To: The Design Advisory Board
From: Mary O'Neil, AICP, Principal Planner
RE: ZP19-0620CA; 9 Lakeview Terrace
Date: March 26, 2019

File: ZP19-0620CA
Location: 9 Lakeview Terrace
Zone: RM **Ward:** 3C
Parking District: Neighborhood
Date application accepted: March 6, 2019
Revised plans received: March 20, 2019
Applicant/ Owner: David DelPiero
Request: Demolish and replace rear (west) addition; change windows in west end, replace vinyl siding with fiber cement board in front, metal in rear. Reconfigure entry to west side of porch, alter south porch roof.

DESIGN ADVISORY BOARD Tuesday March 26h 2019 at 3:00 PM Conference Room 12, City Hall, Burlington, VT

9 LAKEVIEW SITE PLAN PROPOSED REVISION 1

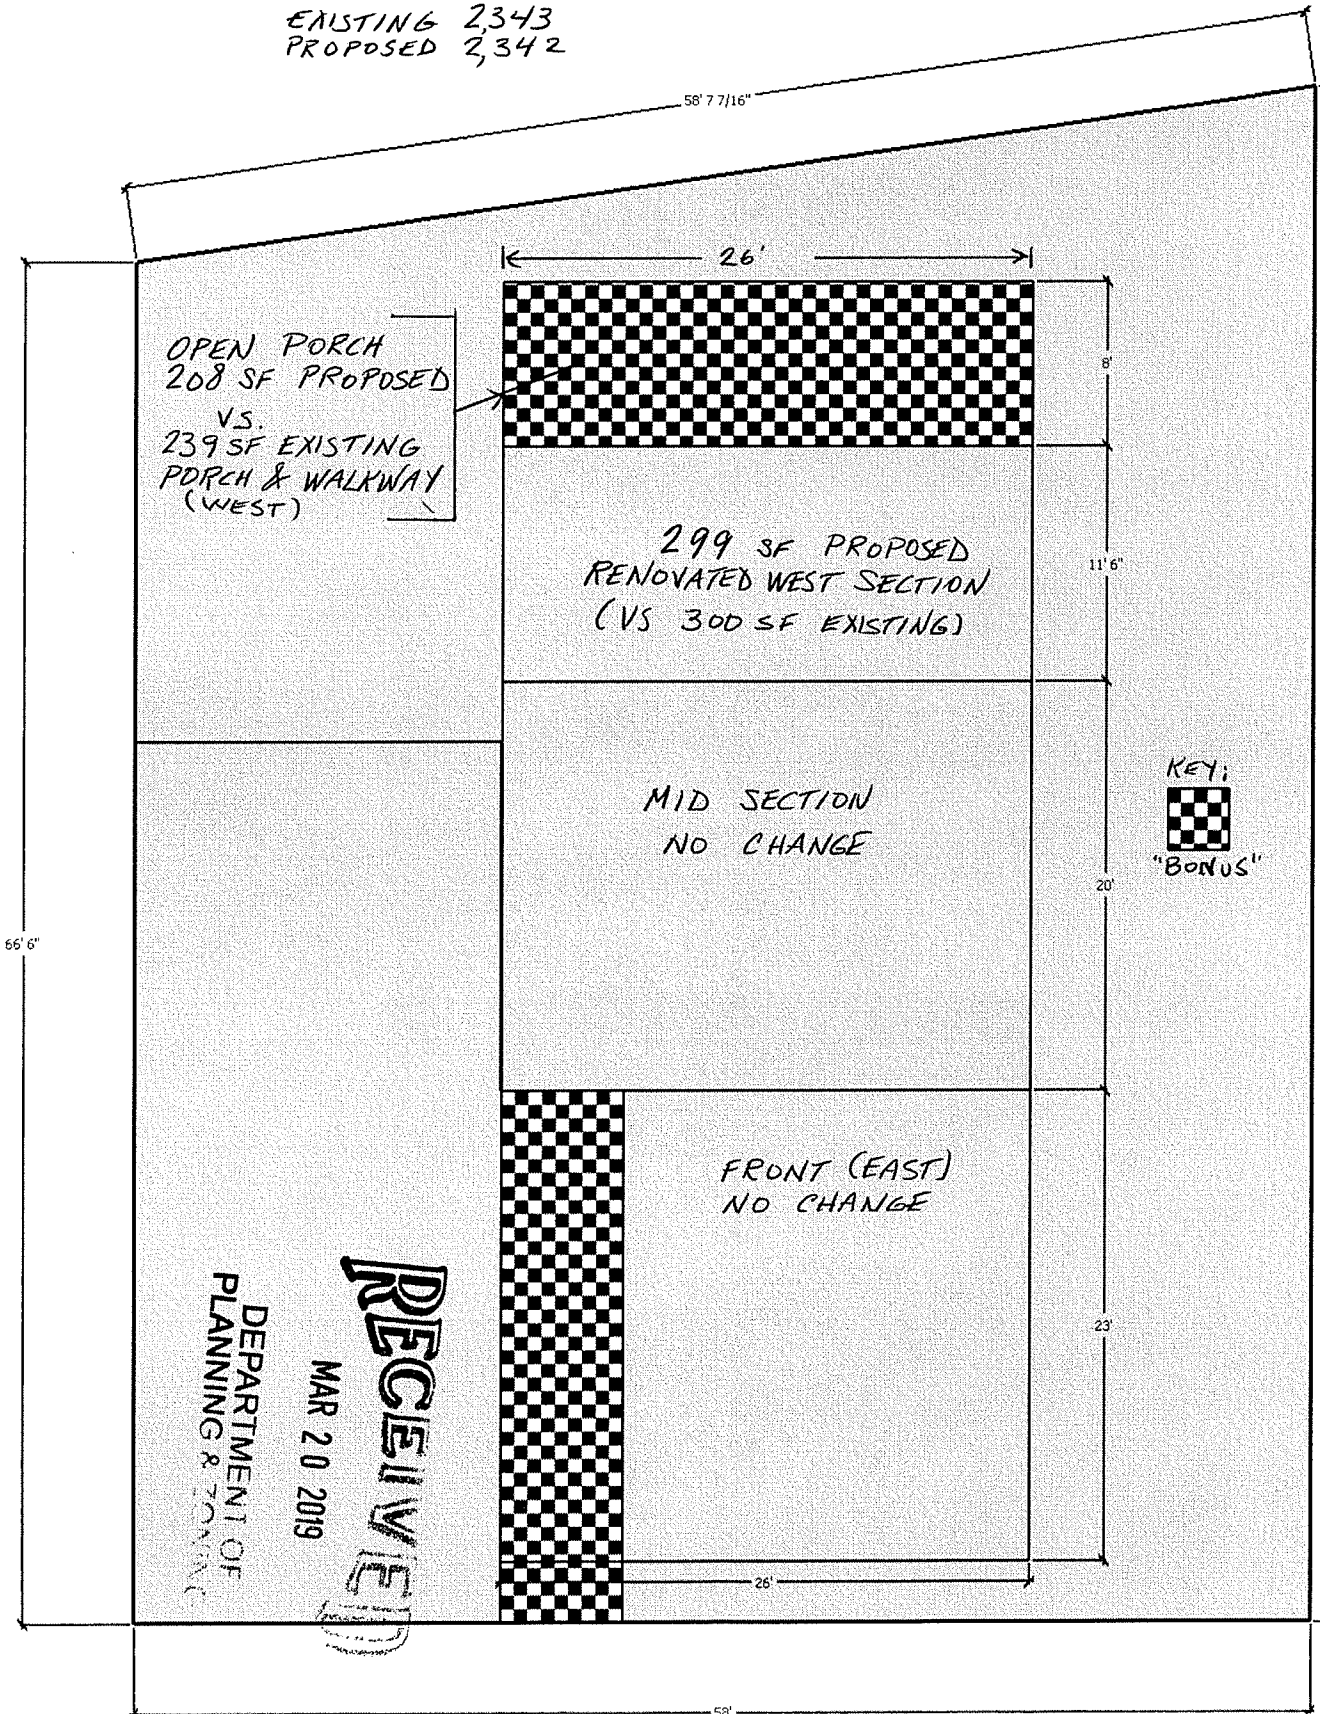
3. The location of meters, utility connections, mechanical equipment, trash and recycling shall be defined and illustrated on the site plan. Trash and recycling shall be enclosed on all four sides to prevent blowing trash.

4. Dimensions for all components, including the driveway, shall be defined on the site plan.
5. Spec sheets and lumen information shall be provided for all new lighting fixtures, as appropriate.

6. The shed roofed south porch shall be retained and incorporated within the plan.
7. The revised south elevation (rec'd March 20, 2019) indicates a partial open porch on the west; while the revised site plan illustrates a full-width porch. Clarification is required.
